July 29, 2014

Subject: **Geotechnical Response to City of Agoura Hills Review Sheet Dated April 18, 2014, Senior Housing Community, Vesting Tentative Tract Number 71742 (APN# 2061-001-025), 30800 Agoura Road, Agoura Hills, California.**

CITY OF AGOURA HILLS - GEOTECHNICAL REVIEW SHEET

BUILDING "B" BUILDING SECTIONS

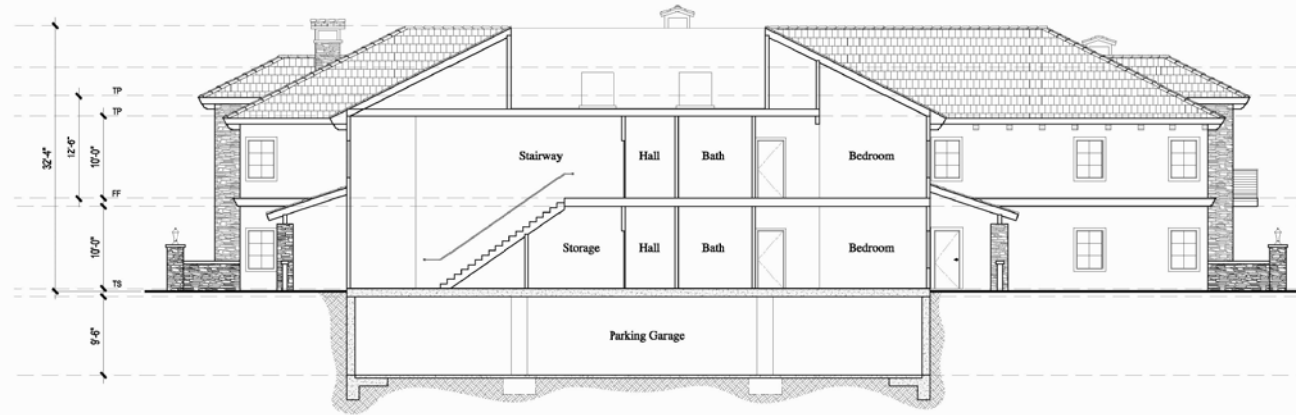
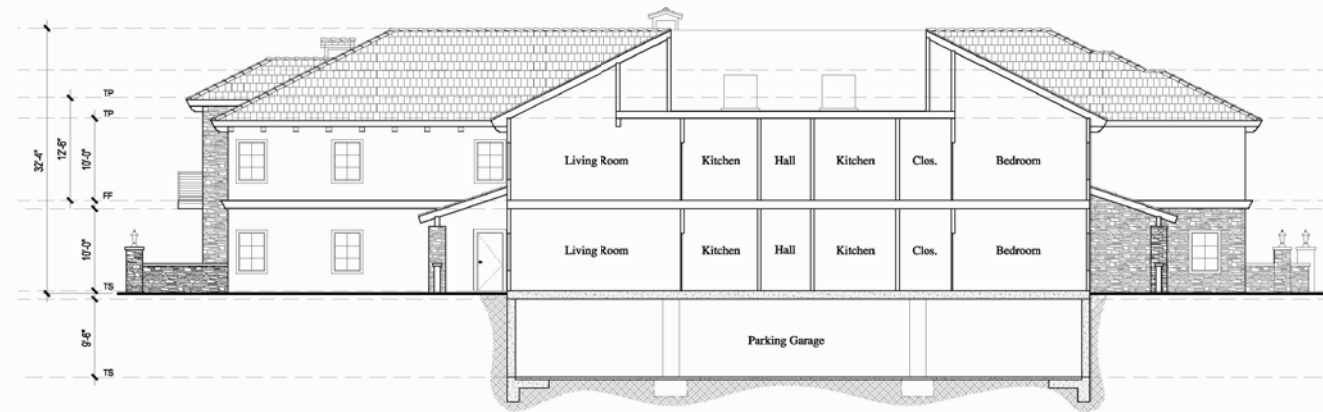
Cross-section C-C' does not seem to fully correspond with the grading plan. Specifically, the consultant should provide the basis for assuming that the subterranean garage does not extend to the outer limits of the building. Please reconcile this apparent discrepancy and revise the section as necessary.

Portions of the above grade portion of the buildings have a slightly larger footprint than the underlying subterranean parking garage. The reviewer is directed to the architectural plans of which architectural exhibits for Buildings A and B are attached for reference as Figures 1 and 2.

WO 2272-1-0-101 Section A-A'

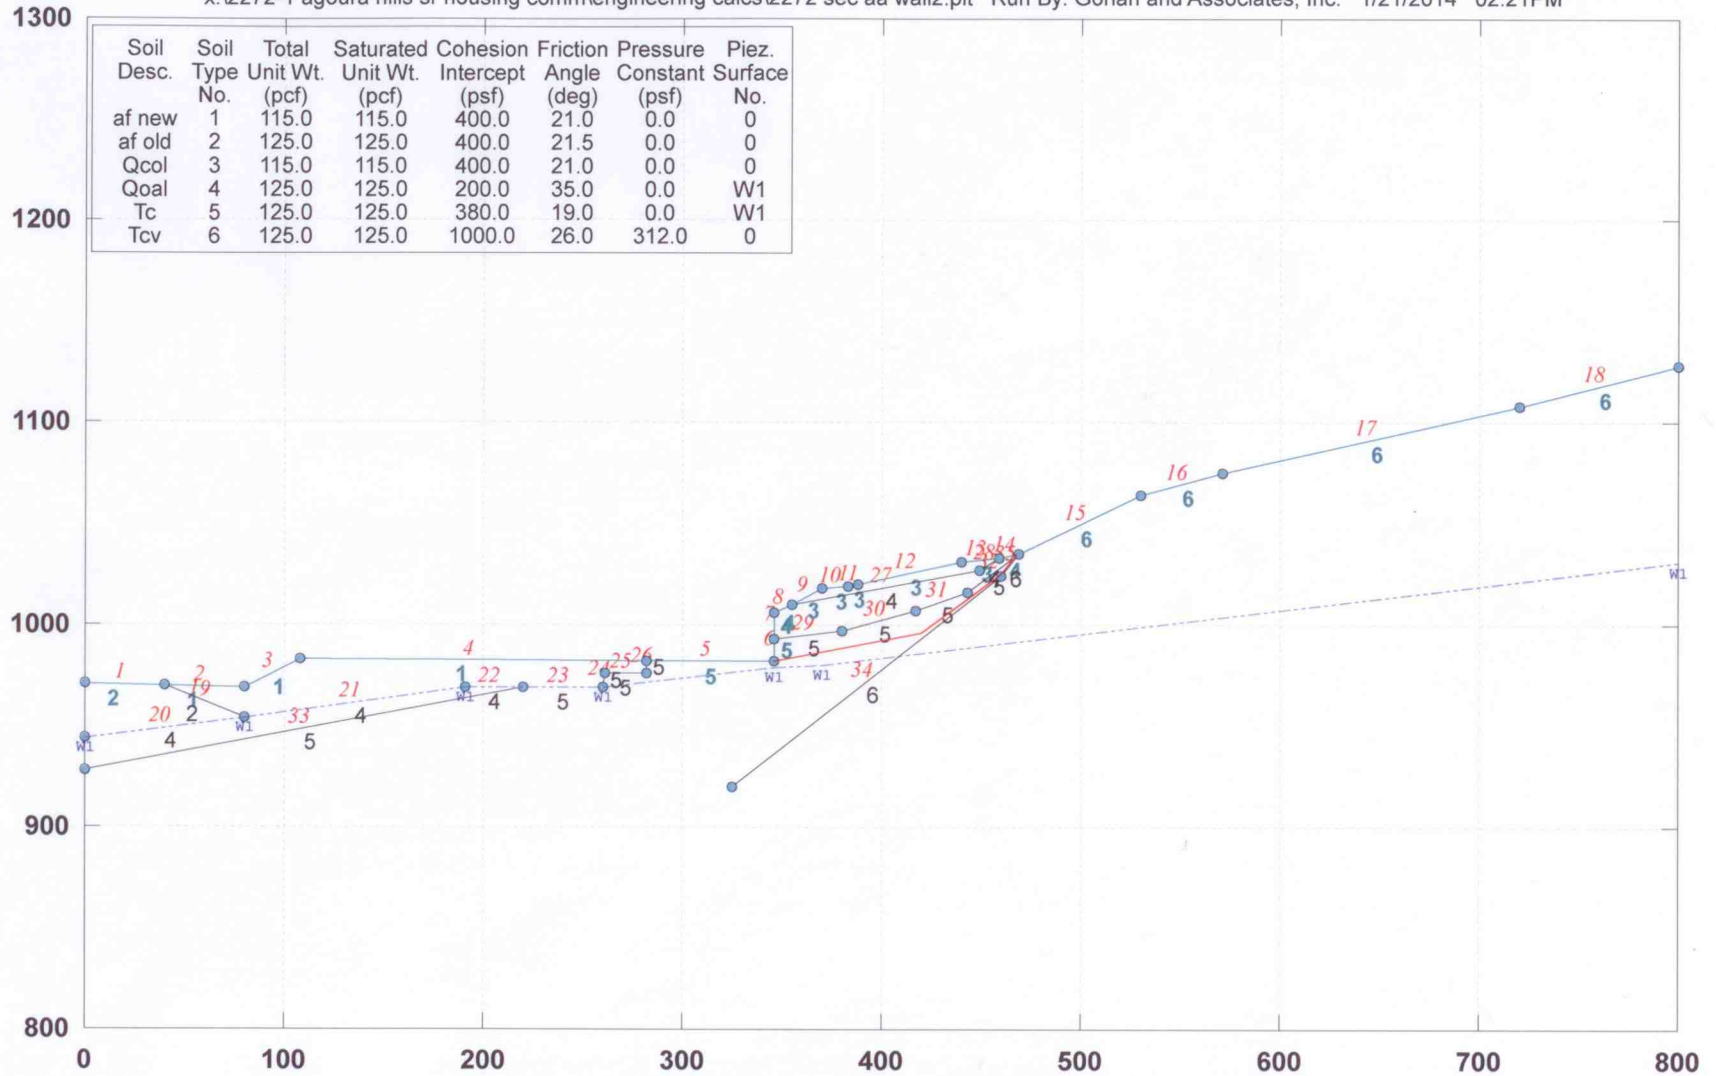
The consultant should evaluate the potential for topsoil/colluvium to exert creep pressure on the retaining walls (example: retaining wall in Cross-Section A-A'). Mitigation measures should be recommended as necessary.

The proposed development includes the construction of an approximately 27ft-high, soil nail retaining wall. The slope stability analyses of the soil nail wall indicate that nail lengths of 25 to 35 ft are required. However, it is not clear if this length includes the resistance length. The consultant should provide a section through the soil nail retaining wall. The section should depict soil/geologic units behind the retaining wall, the wedge to be supported by the retaining wall (example: Rankin Zone), backdrain system, the soil nail resistance zone, and other soil nail geotechnical design considerations.

unconsolidated colluvial sediments. Case in point, within boring B-2 which was excavated directly above the intended soil nail wall the colluvial soils are described as being damp and stiff. In boring B-3, the colluvium is described as hard. A coring barrel with a crowd was needed to excavate the Colluvium below 1 foot in boring B-4. In boring B-1, in place densities are higher in the Colluvium than in the Older Alluvium. In addition, there is no evidence of creep directly adjacent the area of development. Therefore, the surficial stability analysis provided in our reference report of January 30, 2014 is appropriate for the natural and manufactured surface conditions. That analysis resulted in a factor of safety above 1.50.

The analyses of the proposed soil nail wall were provided to show that a soil nail wall is feasible as shown in cross section A-A'. The nail length given is an estimate and does not represent the final design. Typically the entire nail is used for resistance since the wall is basically a reinforced soil mass that acts as a gravity wall. Detailed analyses and design of a soil nail wall should be performed by an engineer who specializes in this type of wall design.

The soil nails may be designed using a pull out resistance of 30 pounds per square foot. Material strength within and behind the soil nail wall should be limited to a friction of 19 degrees and 380 pounds per square foot of cohesion. Maximum vertical excavation lifts should not exceed five feet. The minimum number of test (sacrificial) nails should be equal to or greater than five percent of the total number of required support nails. The locations of test (sacrificial) nails should be shown on the wall plans. Shotcrete may be placed directly against the temporary cut and backfill is not anticipated for the soil nail walls. The design of a soil nail wall may be analyzed as a slope where the nails provide reinforcement of the vertical portion of the slope. This firm should review the final design of the soil nail wall.

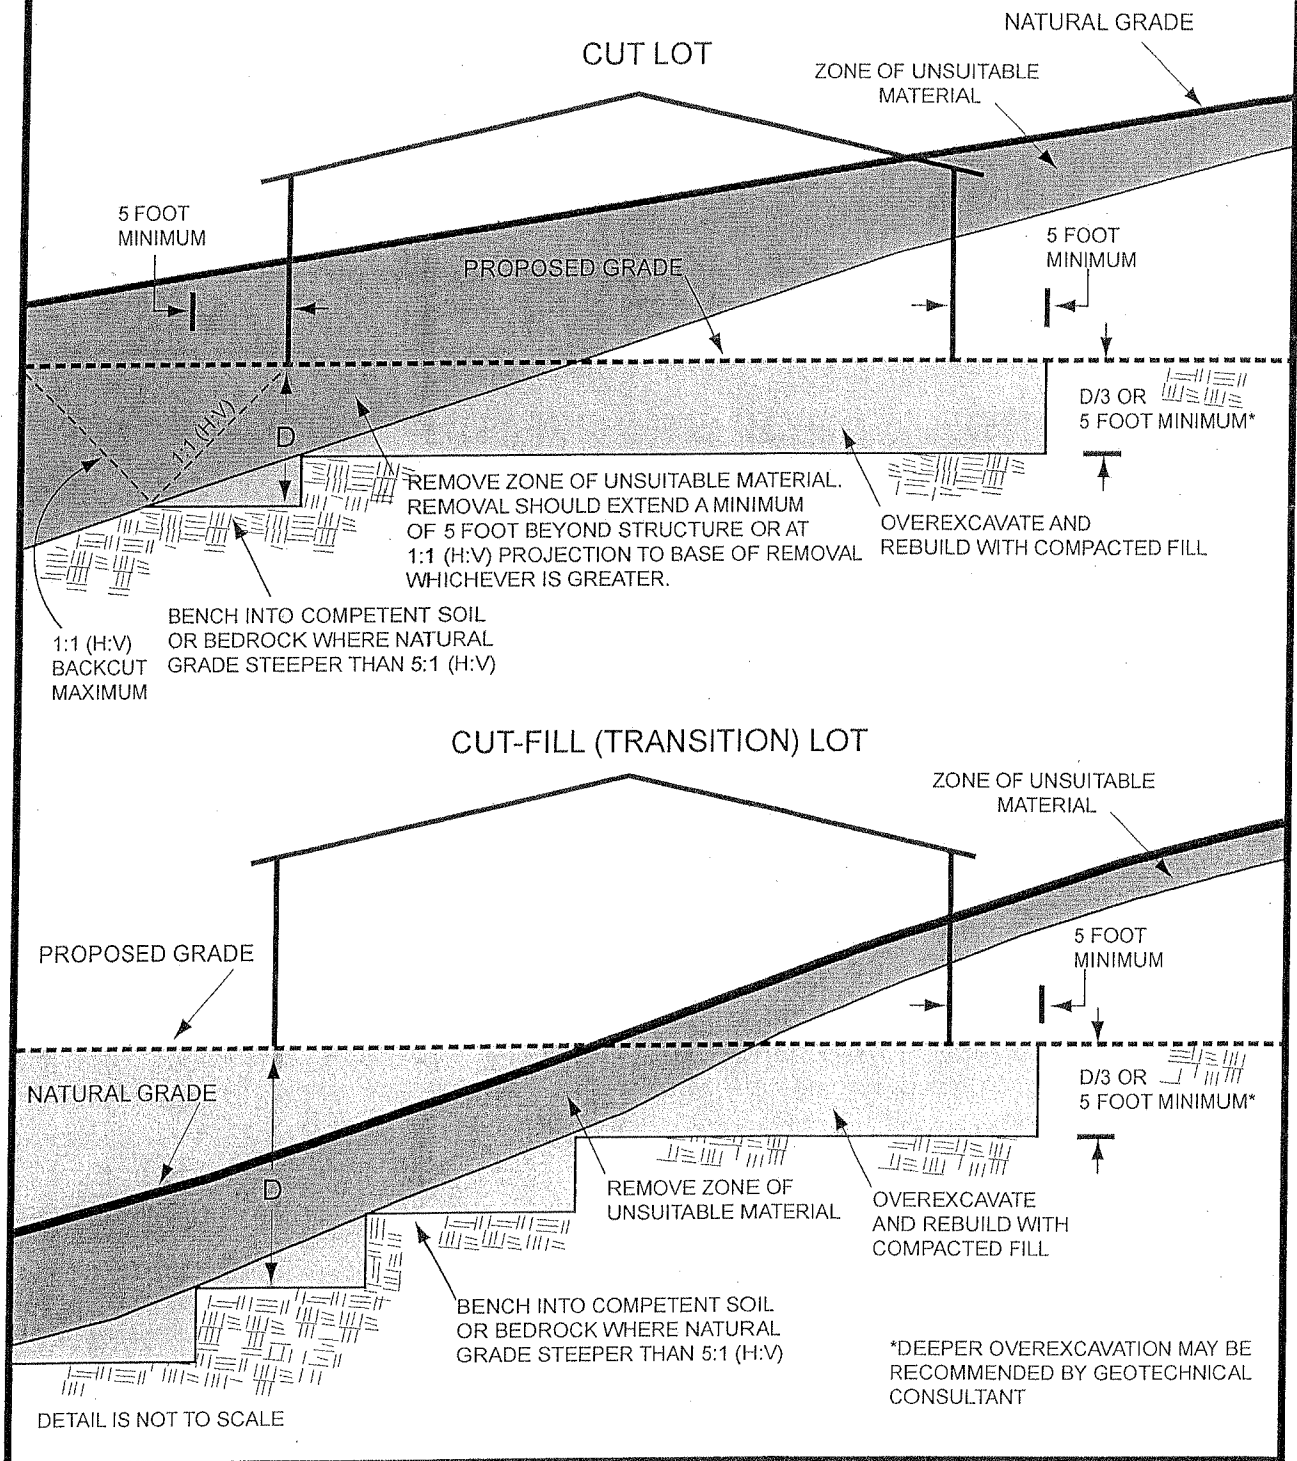
The consultant should perform a geotechnical evaluation, including subsurface exploration in the proposed on-site infiltration areas in accordance with the County of Los Angles Guidelines and Manuals.

A shallow infiltration test pit (IP-1) was excavated in the proposed basin in the southwest corner of Agoura Road and the proposed driveway to Building B. The approximate location of the infiltration pit is shown on Plate 1. A one foot square test pit was excavated into the Older Alluvium at the bottom of the 5.75 foot deep pit and developed as a test hole in which to perform stormwater infiltration testing in general accordance with the County of Los Angeles Guidelines for Design, Investigation, and Reporting Low Impact Development Stormwater Infiltration (LID).

The test results were recorded in tabular form and are attached in Appendix C. The measured rate was then adjusted to account for discharge of water from both the sides and bottom of the hole to develop a representative infiltration rate. The final rate was determined to be 0.09 inches per hour.

The results of the infiltration testing are a rate of 0.09 inches per hour, which is less than the minimum requirement of 0.3 inches per hour in the County's LID manual. In addition, the invert of the infiltration is to be a minimum of 10 feet above the groundwater level. However, the Seismic Hazards Zone Report indicates groundwater at a depth of 10 feet along Agoura Road. Therefore, for these reasons stormwater infiltration on site does not appear to be feasible.

BUILDING PAD OVEREXCAVATION TYPICAL DETAIL

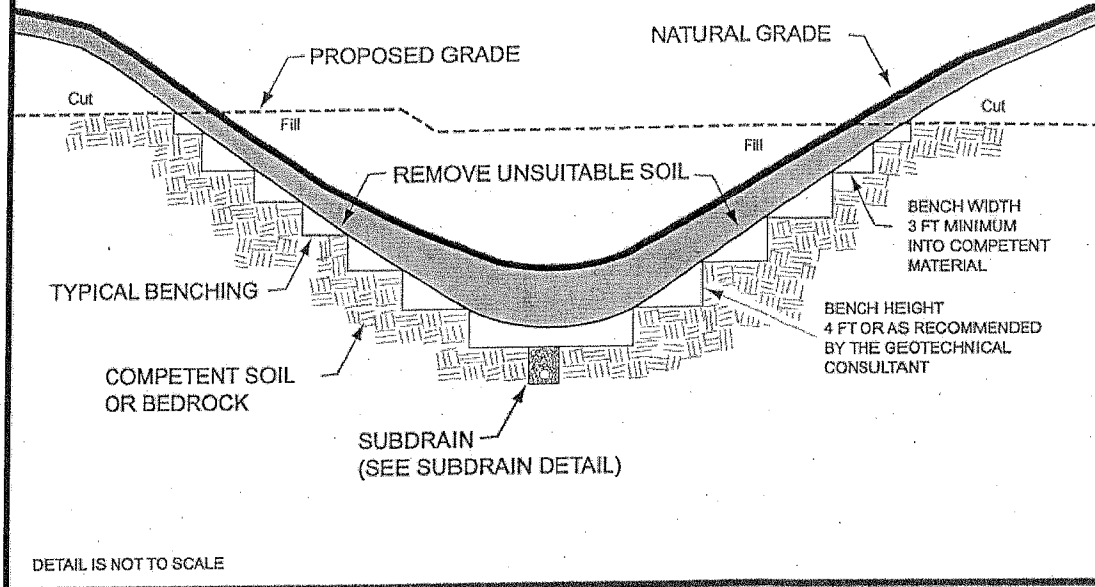
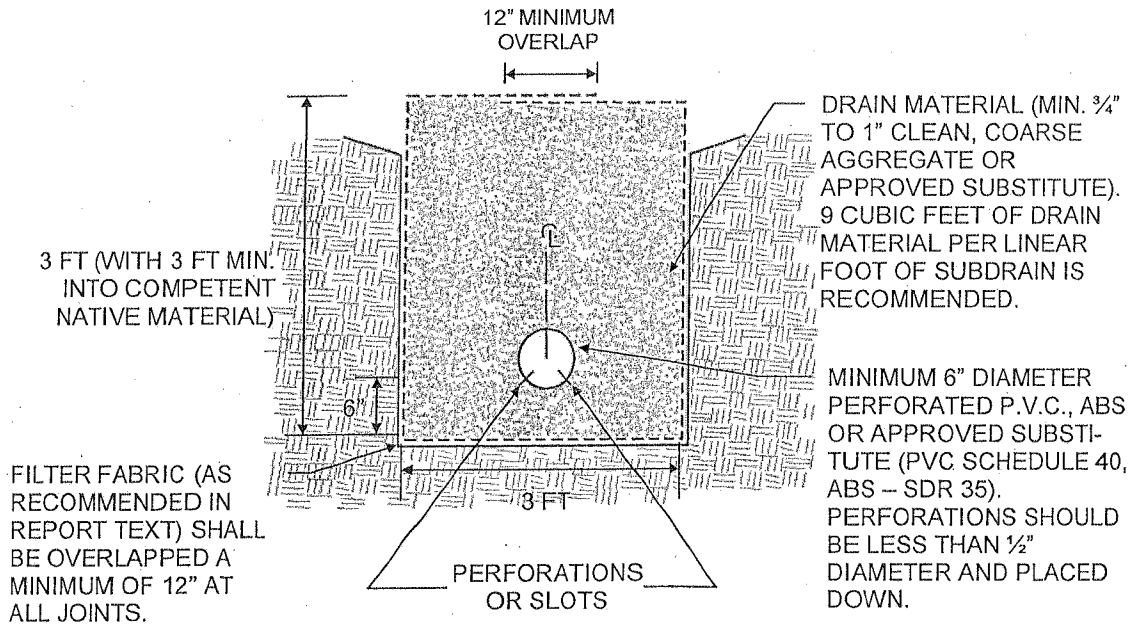
The consultant indicates on page 18 of the above-referenced report that "a Building Pad Over-Excavation Detail is attached in Appendix D." This detail, as well as other details (see page 20 of the above-referenced report) are missing. All missing details should be provided for review.

The details from the reference report are attached hereto in Appendix B.
